Service information

Reference no.: SDA_86702

Exhaust grill is getting loose during cleaning a certain time

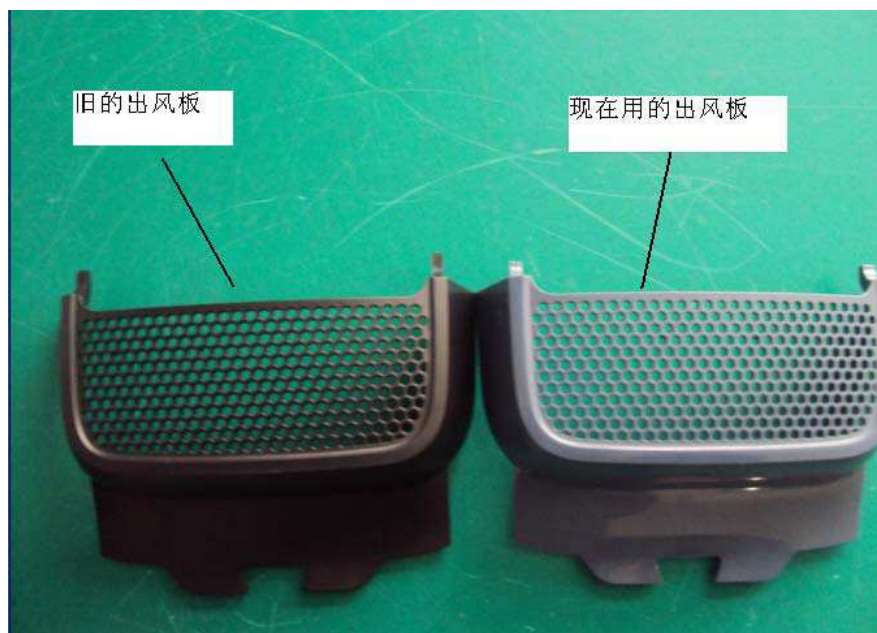
INFO: During the cleaning it can happen that Exhaust grill plops out because of the temperature.

CURE: Construction has been changed so that this problem will not occur again.

REMARK: When problem occurs : exhaust grill needs to be replaced by new one, 12 NC: 4222 459 47871

See picture : left is old grille / right is new
